# **Planning and Development (Technical Amendment — Changes to a commercial precinct code and general codes) Plan Variation 2009**

**Technical Amendment No 2009-36**

# **Technical Amendment to the Territory Plan Code Variation 2009-36**

Changes to a commercial precinct code and  
general codes

**Figure 2.1 Indicative Kerb Ramp Position for 90° Parking Spaces for people with disabilities in cases where the parking space(s) abut a footpath or access way**

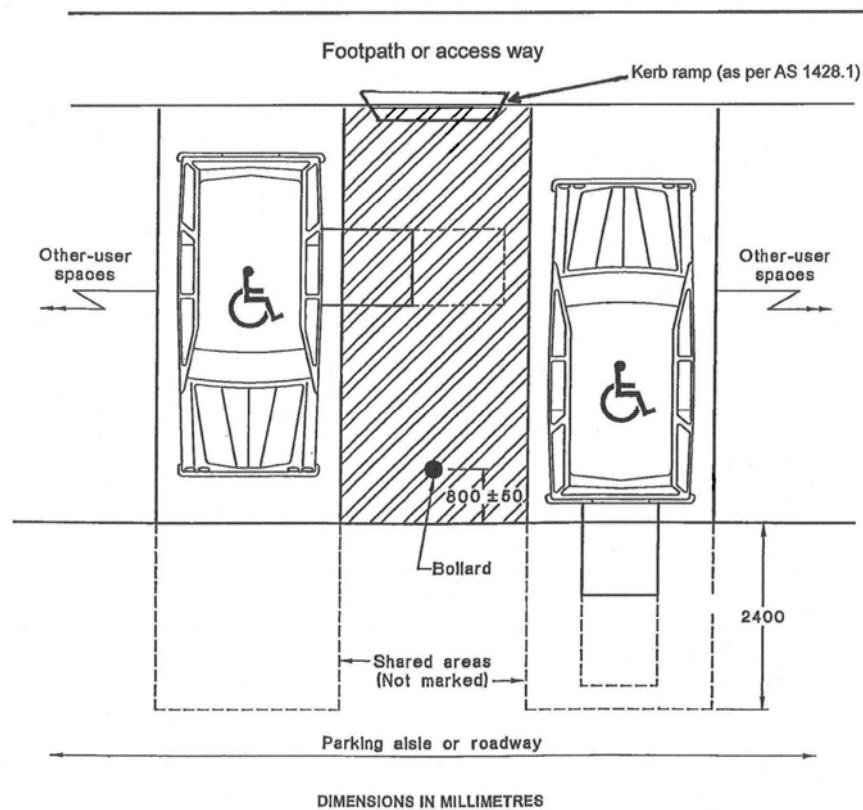
Notwithstanding the provisions of Section 2.5 of *Australian Standard AS/NZS 2890.6.2009 Parking Facilities – Part 6: Off-street parking for people with disabilities* in relation to the position of kerb ramps, kerb ramps shall be placed in the middle of the shared area where the parking spaces are located within a surface or multi-level, off-street car park, or at either end of the parking space in the case of on-street parking spaces.

Where the front or rear of a parking space for people with disabilities abuts a kerb which forms the edge of a footpath or access way providing access to or egress from or within the car park, kerb ramps shall be provided from the parking spaces or shared areas to the access way or footpath (**Figure 2.1**)
